RE: RESPONSE TO SUBMISSIONS - LANDSCAPE

The following letter provides response to all submissions received that are relevant to the proposed landscape design.

Fig 8.1 Landscape Zonal Plan

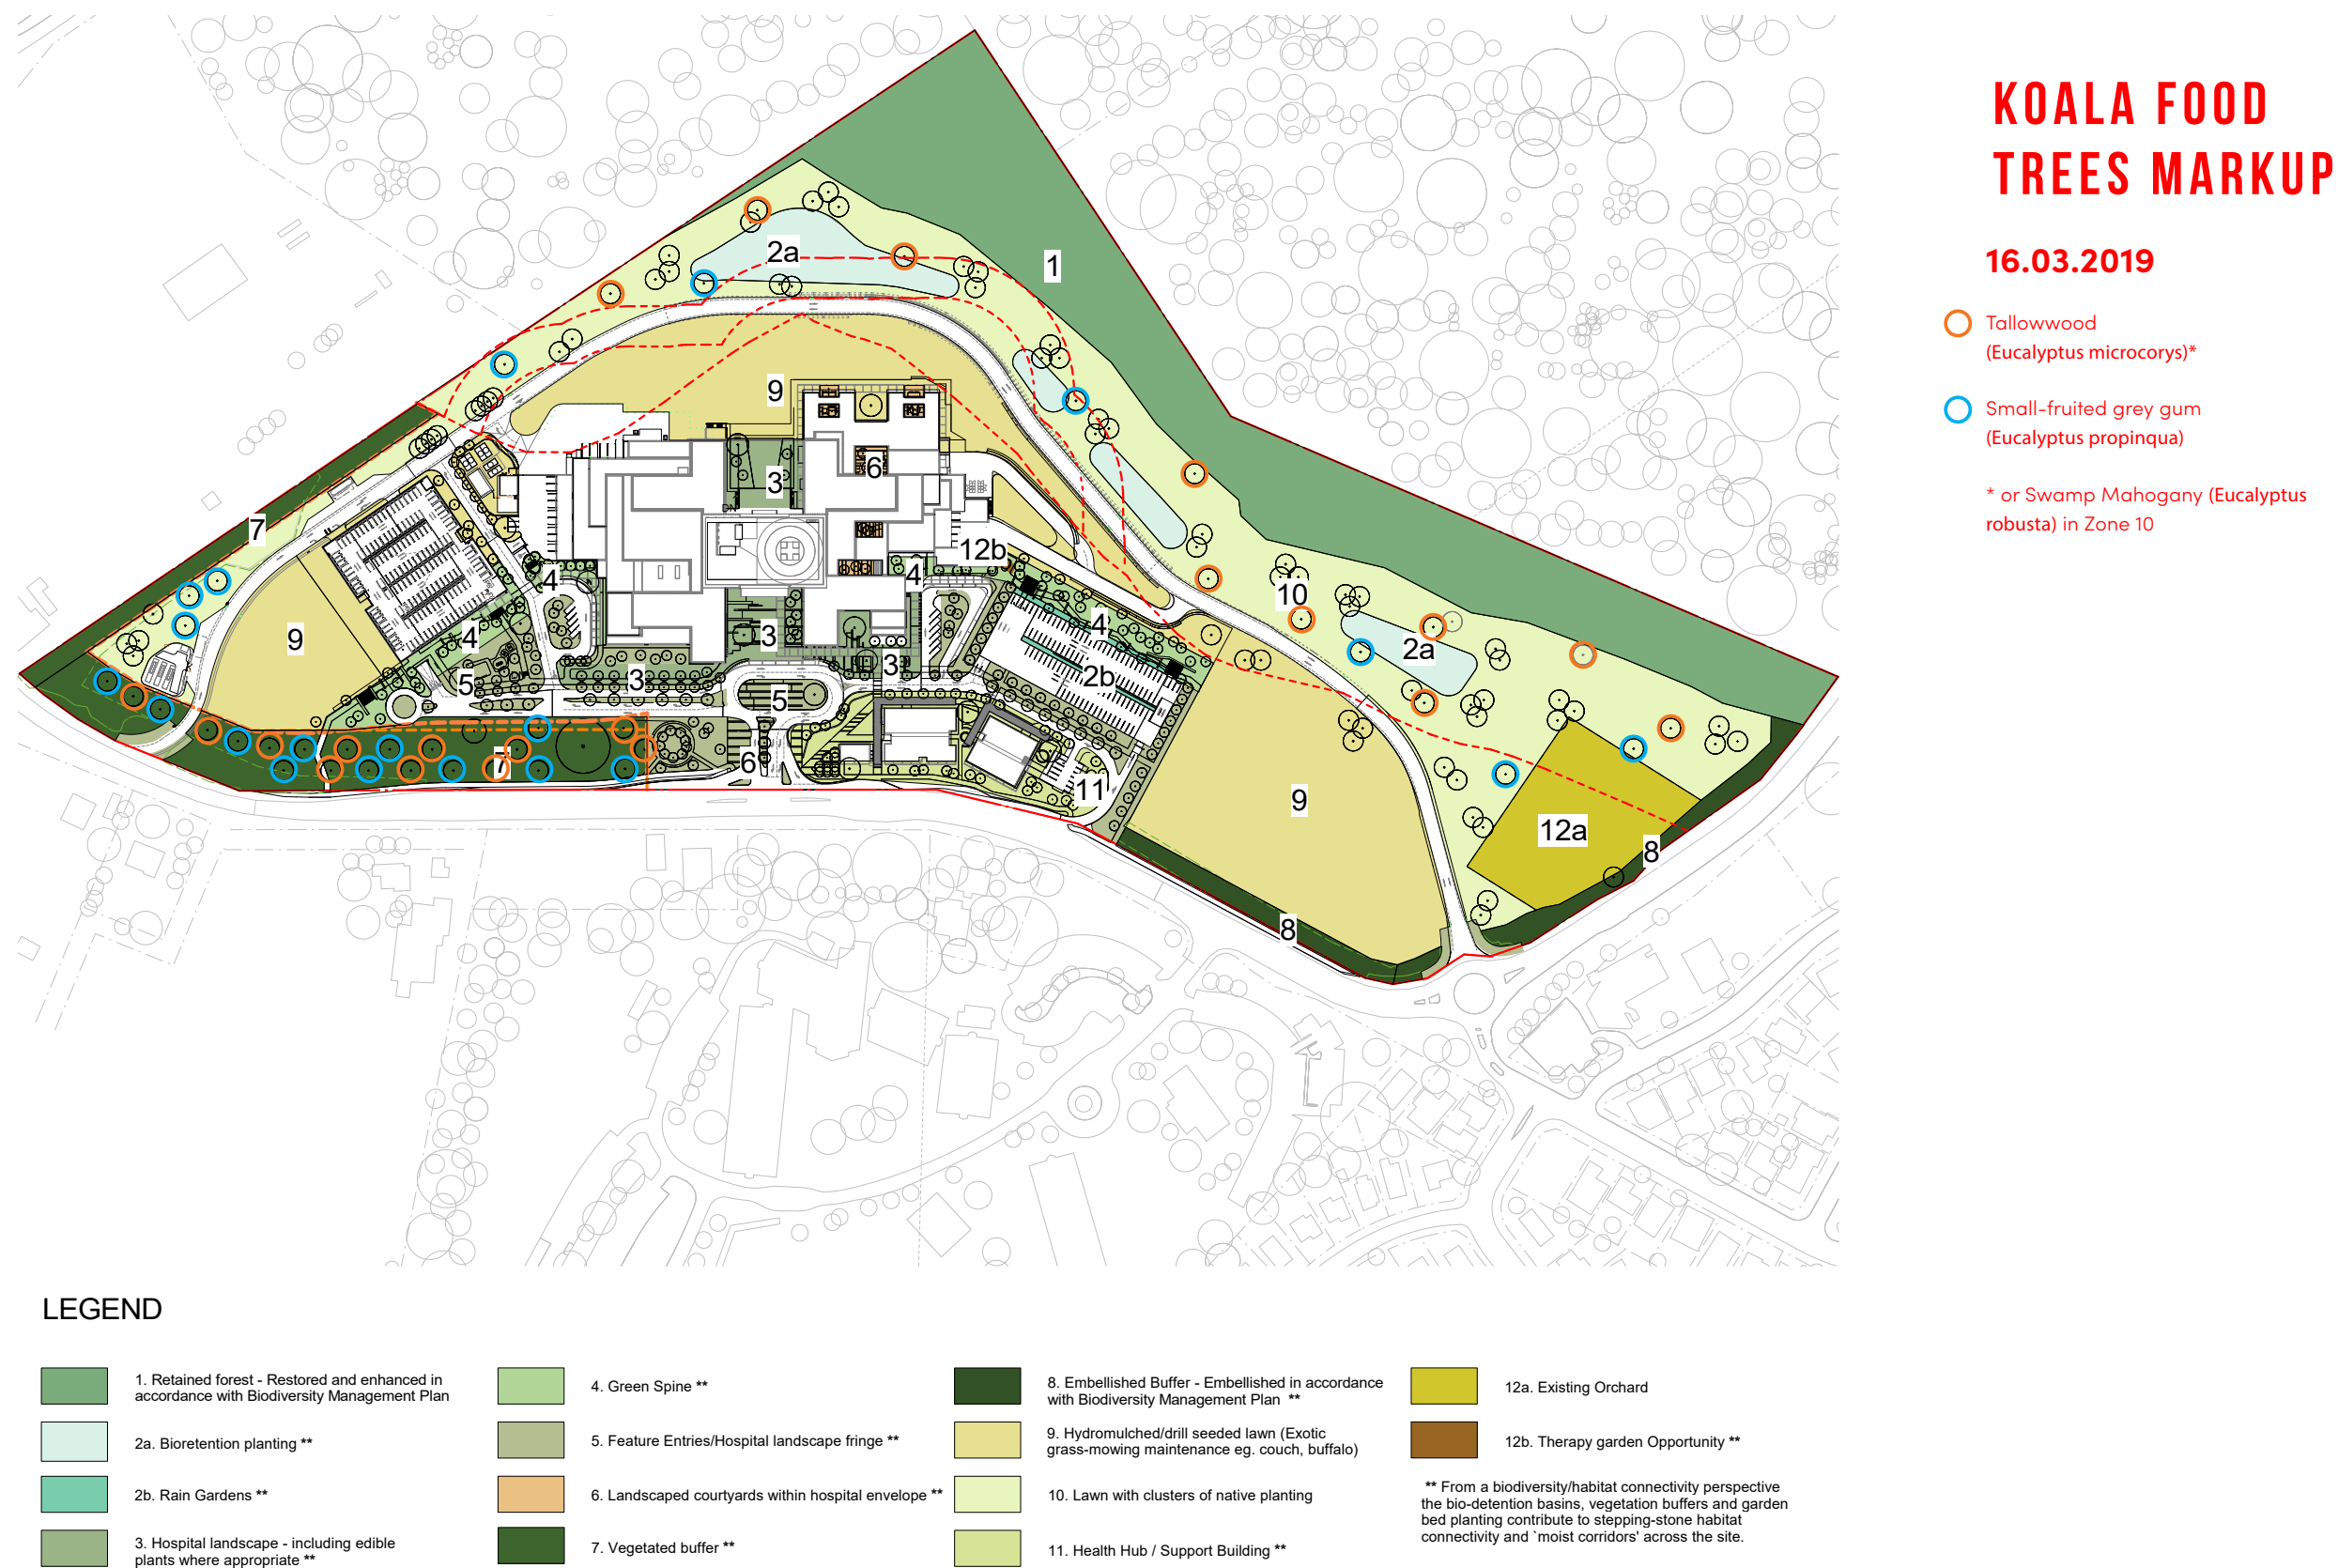
<i>4b. The turf report should provide details of how many koala food trees will be planted and the locations of these plantings</i>	A total of 42 koala food trees will be planted, evenly distributed within landscape zones 7 and 10. Refer BCD4c below for further details, and “Koala Food Trees Markup” plan attached.
<i>4c. Consideration be given to planting koala food trees in the south west corner (area 7 in the landscape zonal plan (LZP)) and lawn area</i>	Planting of Koala food trees has been considered in these areas, and the following approach is proposed...

<p>76. Condition B7 states “The site plan and the landscape masterplan for the Stage 2 application must include the following as identified in the approved Landscape Zonal Plan prepared by Turf Design Studio dated 03/05/2019:</p> <p>(i) details of ‘Koala food trees’ to be planted in proximity to the identified potential koala habitat locations in vegetation Zone 6 of the Biodiversity Development Assessment Report prepared by Greencap dated January 2019.”</p>	<p>(as mentioned in the comments).</p> <p>A total of 20 koala food trees are incorporated into the adjacent Zone 10 planting area (refer landscape zonal plan), spacing in accordance with canopy separation requirements for APZ.</p> <p>In addition to this, 22 Koala food trees are proposed in Zone 7, adjacent to Zone 10.</p> <p>For specific details of proposed locations for Koala food trees, please refer BCD 4c above, and “Koala Food Trees Markup” plan attached.</p>

<p>77. This condition is not clearly addressed. Koala food trees appear in broad planting species lists, but the Landscape Plans and BMP do not provide specific detail or direction on the use of these trees in the location required by this condition. It is suggested that the relevant plans are revised to provide this detail.</p>	<p>For specific details of proposed locations for Koala food trees, please refer BCD 4c above, and “Koala Food Trees Markup” plan attached.</p>

A total of 22 koala food trees (11 of each species) will be planted in locations as shown on the landscape zonal plan.

A total of 20 Koala food trees (an even mix of available recommended species, evenly distributed throughout the zone) will be integrated into the existing tree planting general arrangement, in accordance with the above canopy separation requirements. Refer "Koala Food Trees Markup" plan attached.
